**Amendments to the Drawings:**

FIG. 7

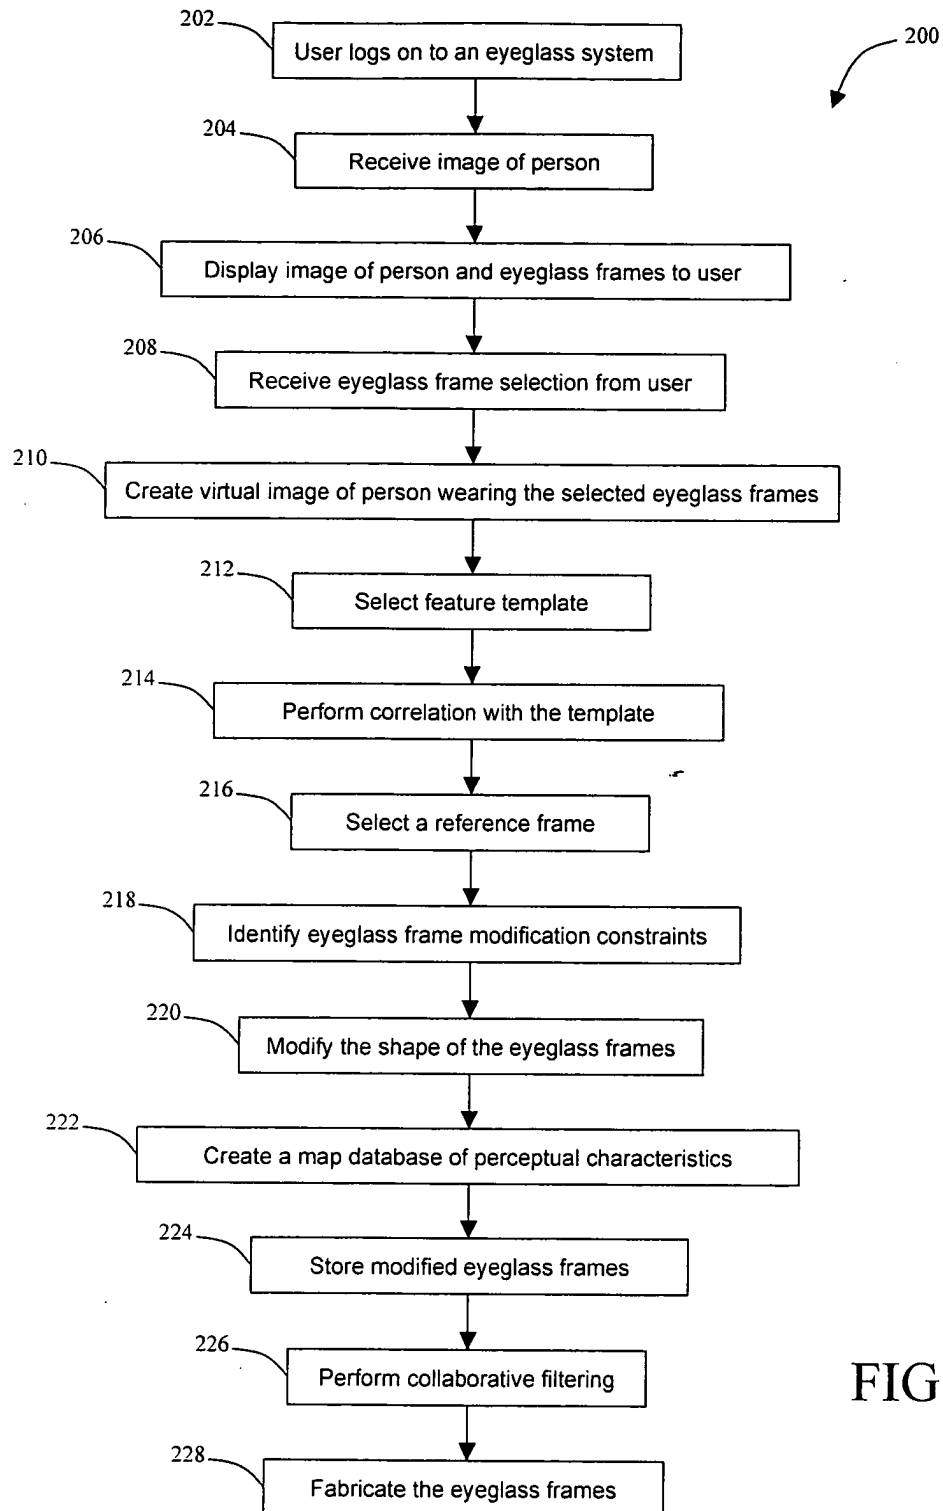
The Examiner objected to the Fig. 7 of the drawings under 37 CFR 1.84(h)(5) because Figure 7 show(s) different use of “frame” in the same view. The Examiner stated that it is not clear whether the “frame” used in all of the steps of Fig. 7 are the same or different from “glass frame” used in step 228. The Examiner required the submission of corrected drawing sheets to avoid abandonment of the application.

In response to the Examiner’s objection to Fig. 7 of the drawings and requirement for corrected drawing sheets, Applicant submits with this Amendment and Response to Office Action the attached Replacement Sheet for Fig. 7 of the drawings, which clarifies the "frame" used in all of the steps of Fig. 7.
